SERVICE BULLETIN

SERVICE BULLETIN NO: 25-031

EQUIPMENT/FURNISHINGS - FLIGHT COMPARTMENT CREW SEATS - INSPECTION OF THE BUCKET ASSEMBLY TUBES

Inspection of the Bucket Assembly Tubes Adjacent to the Energy Devices
 Figure 1

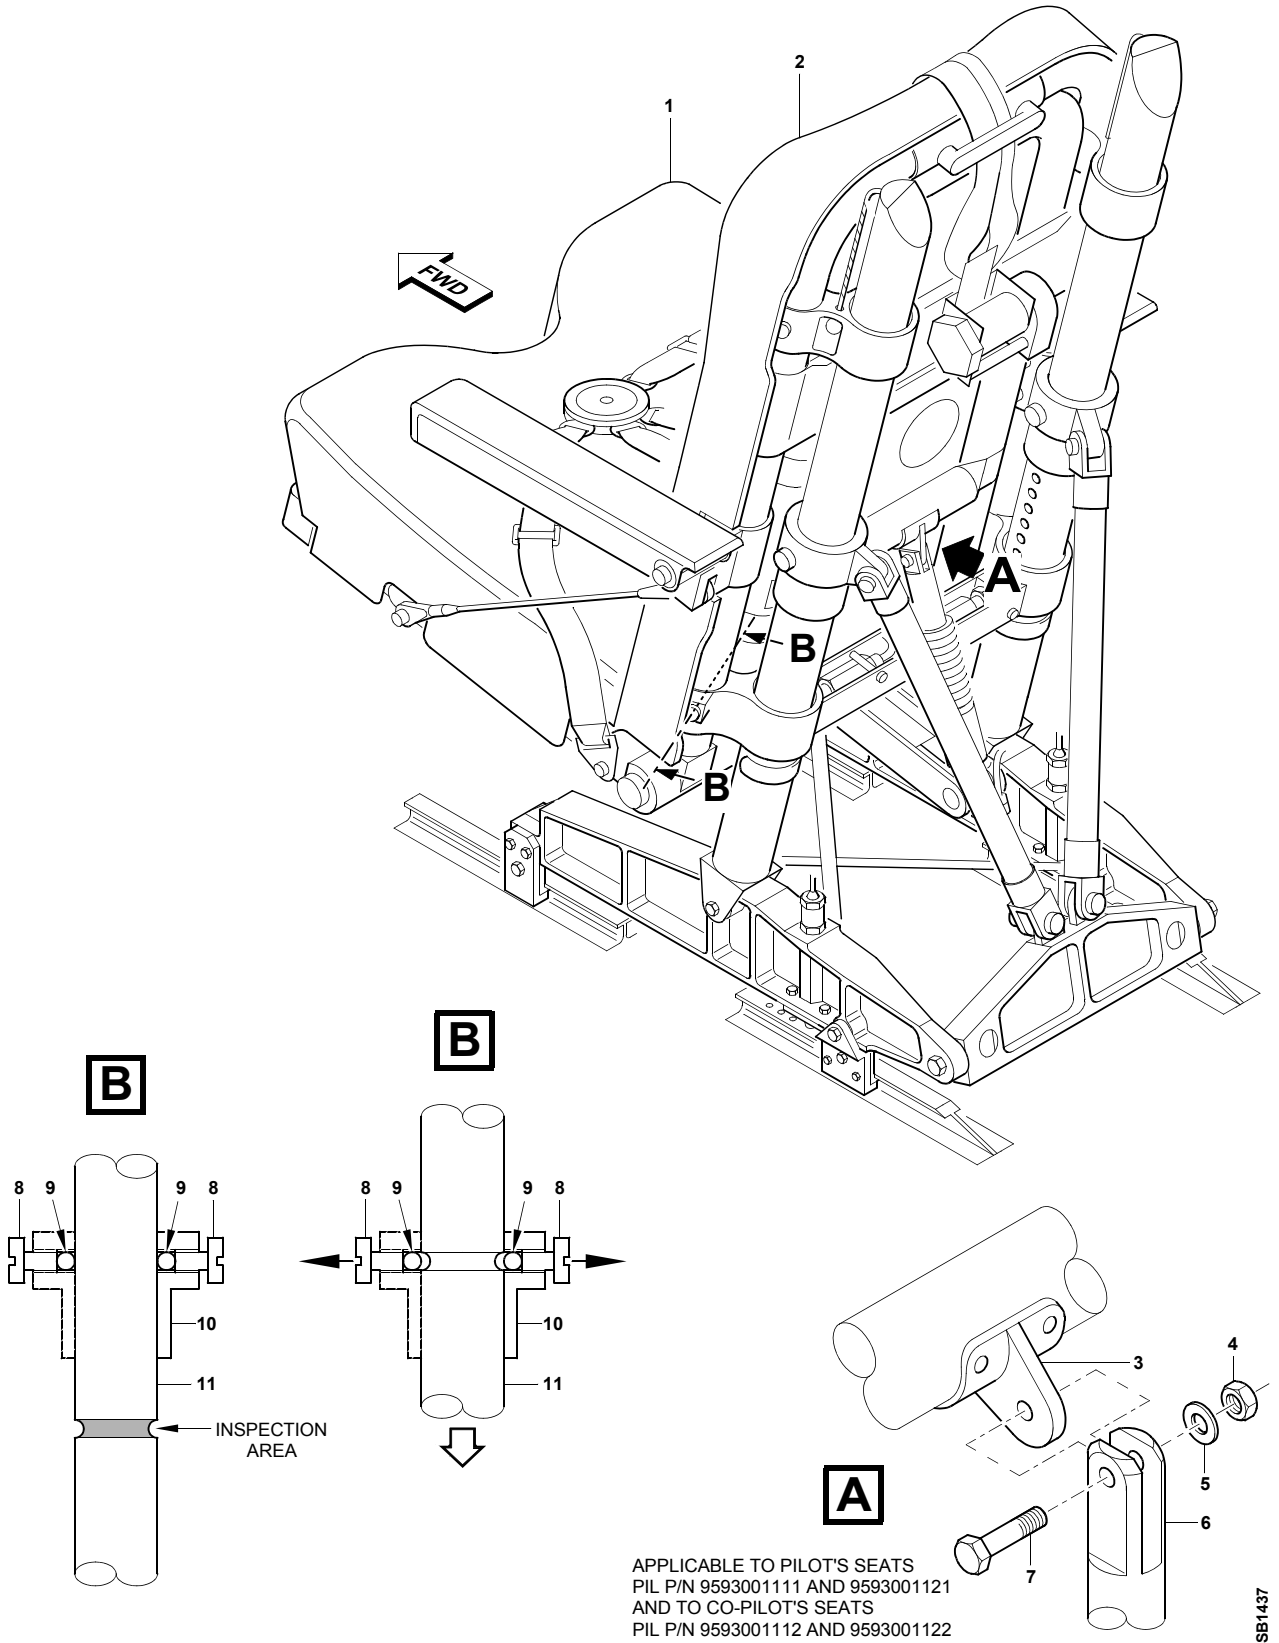
The bucket assembly tubes on one of the crew seats failed. It was found during a maintenance inspection.

The bucket assembly tubes failed at the location of the energy device pins. The lower tubes remained attached but the upper parts were completely disconnected.

- (7) Do a fluorescent dye-penetrant inspection of the grooved area of the bucket assembly tubes (11). Crack(s) are not permitted.

- (8) If you find crack(s):

- Contact PILATUS for a repair procedure to replace the bucket assembly. Give the aircraft Serial Number (S/N) and the seat S/N and flying hours
- Continue with this procedure.

- (13) Permit the bucket assembly to move up the bucket assembly tubes (11) until you can feel the ball bearings (9) go into the groove of the bucket assembly tubes (11).
- (14) Keep the bucket assembly in this position and torque the four energy device pins (8) to between 5,42 and 5,65 Nm (48 and 50 lb in).
- (15) Secure each pair of the energy device pins (8) with the lockwire (Mat. No. P02-001).
